Slurry Pipeline Project

NMDC/SPL/AS(1)

30.06.2018

Sub: Diversion of forest land for non-forest purpose under Forest Conservation Act, 1980 proposed land for associated Facilities of Conveyor Gallery, Iron Ore Concentrate Pipeline and Tailing Dam, area 7.116 Ha. reg.

# JUSTIFICATION FOR 30 MTR ROW FOR LAYING SLURRY PIPELINE

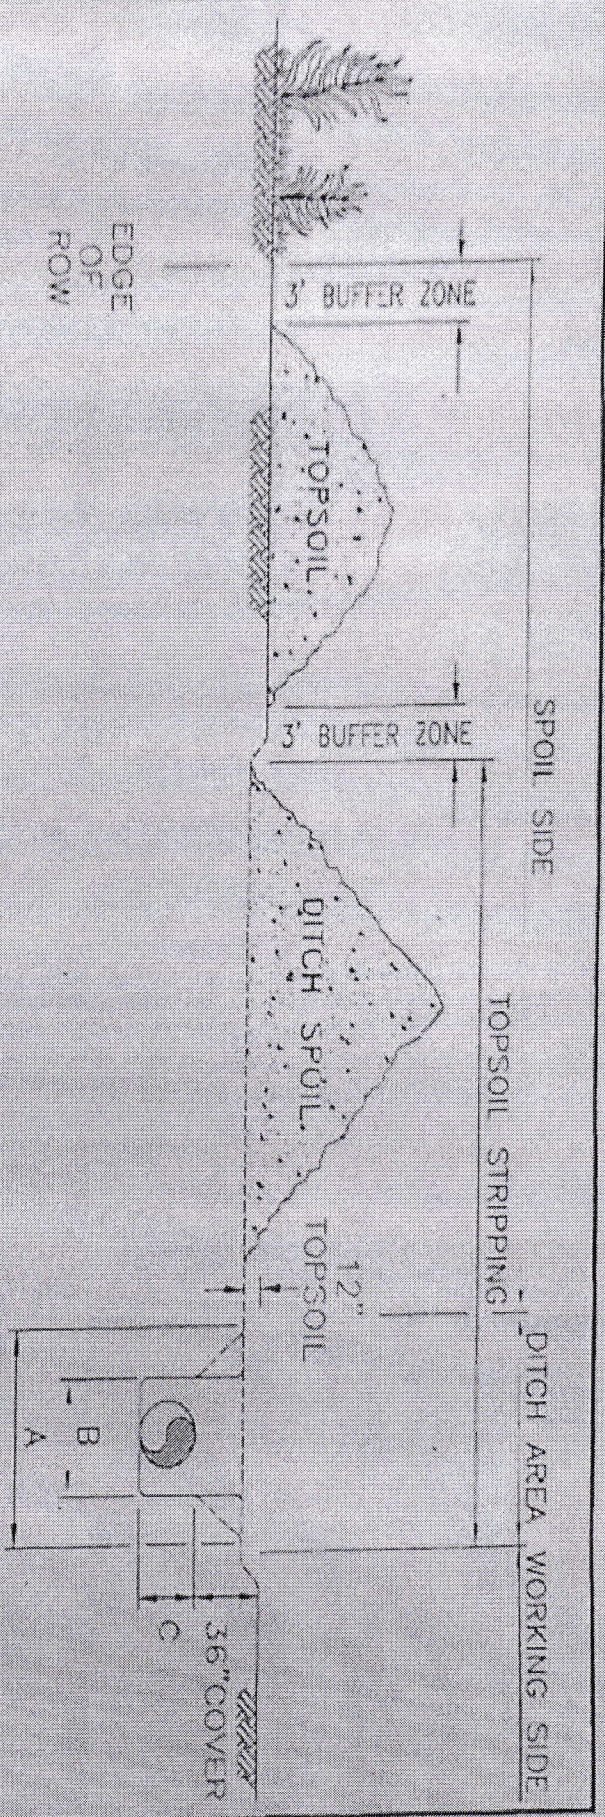
**Reply against point no.2:** The details of Associated facilities consists of various facilities are given in the below table. The cross section of the Conveyor & Slurry Pipelines has been enclosed at page no. 172 & 173 of 44-point checklist point which was submitted to your office on 23.04.2018. The same was also uploaded on the online portal. Further it is submitted that 30 M corridor is international standard(enclosed as Annexure-2) for laying the pipeline system and same corridor is being used for conveyor system thereby saving forest area. It is also submitted that the ground profile of some portion of the proposed area is undulating and sloppy terrain. Therefore, proper approach system is required for movement of machinery like dozer, loader and excavator etc during erection of pipelines.

PIPE DIAMETER	WORKSPACE TO STOCKPILE SPOILS				DITCH DIMENSIONS			TOTAL WORKSPACE FOR DITCH AREA AND SPOIL SIDE
	BUFFER ZONE	TOPSOIL	BUFFER ZONE	DITCH SPOIL	A	B	C	
0" - 16"	3'	10'	3'	14'	6'	3' - 4"	16"	16'
18" - 24"	3'	14'	3'	19'	8'	4'	24"	47'
30" - 36"	3'	20'	3'	24'	10'	5'	36"	60'
40" - 42"	3'	20'	3'	29'	12'	5' - 5"	42"	67'
